A.C.S. SUBDIVISION

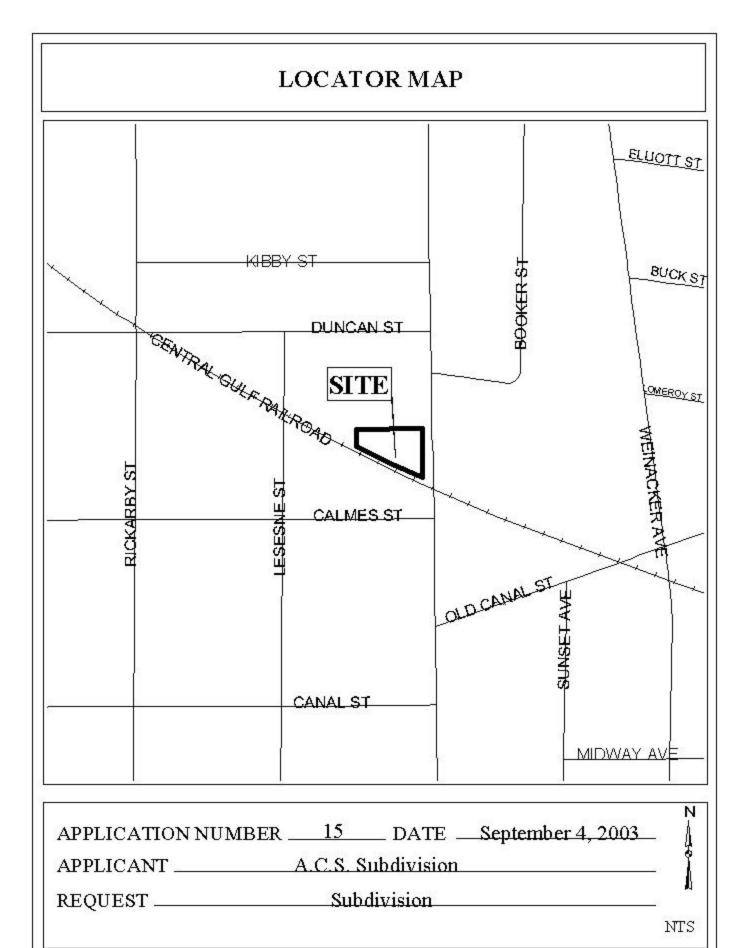
The plat illustrates the proposed 1 lot, $0.3 \pm \text{acre}$ subdivision which is located on the Northwest corner of Houston Street and the Illinois Central Gulf Railroad right-of-way. The subdivision is served by public water and sanitary sewer.

Houston Street, which is a planned major street, has an existing right-of-way in compliance with the Major Street Plan. However, as a means of access management, the placement of a note on the final plat stating that Lot 1 is limited to one curb cut to Houston Street, with the location, size, and design to be approved by Traffic Engineering, should be required.

As illustrated on the Vicinity Map, it seems that two parcels to the North of the proposed subdivision were deeded off via a metes and bounds description and should be included in the subdivision.

The plat meets the minimum requirements of the Subdivision Regulations and is recommended for Tentative Approval subject to the following condition: 1) the placement of a note on the final plat stating that Lot 1 is limited to one curb cut to Houston Street, with the location, size, and design to be approved by Traffic Engineering, should be required.
